SERVICE BULLETIN

PU-08-001

Product Update: Hendrickson Aftermarket Height Control Valve

LIT NO: P56019

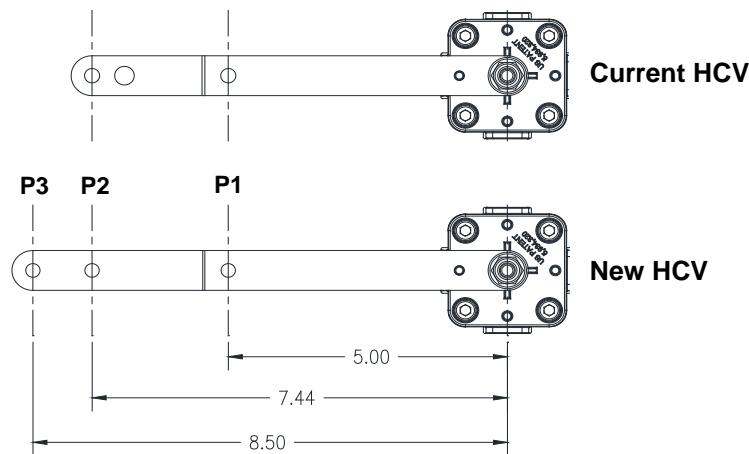
Hendrickson Trailer Commercial Vehicle Systems announces a change to aftermarket Height Control Valves (HCVs). Beginning mid-June 2015, the HCV control arms will be extended in length by one inch and modified to include a third mounting hole. To determine the proper mounting hole for a specific suspension, refer to the chart below.

The function of the height control valve is unaffected by these modifications. This control arm change applies to Hendrickson aftermarket replacement HCVs only and current replacement part numbers are unchanged. Therefore, VS-227 and VS-227-BK (Standard HCV), and VS-228 (Integral Dump HCV) aftermarket kits will include the new HCVs. Components are fully reverse compatible. Please note, these replacement valves are designed to work on all Hendrickson suspension models **excluding** VANTRAAX® ULTRA-K®.

SUSPENSION MODEL *	LOWER HCV BRACKET LOCATION	HOLE
INTRAAX® - AANT, AAT, AANL, AANLS	Attached to brake chamber bracket	P1
VANTRAAX® - HKANT, HKAT, HKARL		
INTRAAX-SP - AAZNT		
HT™ Series - All non "US" models		
HK™ Series - All		
HS Series - All		
INTRAAX - AAL, AAEDL, AAEDT	Attached to air spring pedestal	P2
VANTRAAX - HKAL		
INTRAAX-SP-AAZL		
HT Series - HT250US, HT300US		
VANTRAAX - HKANT, HKAT		P3
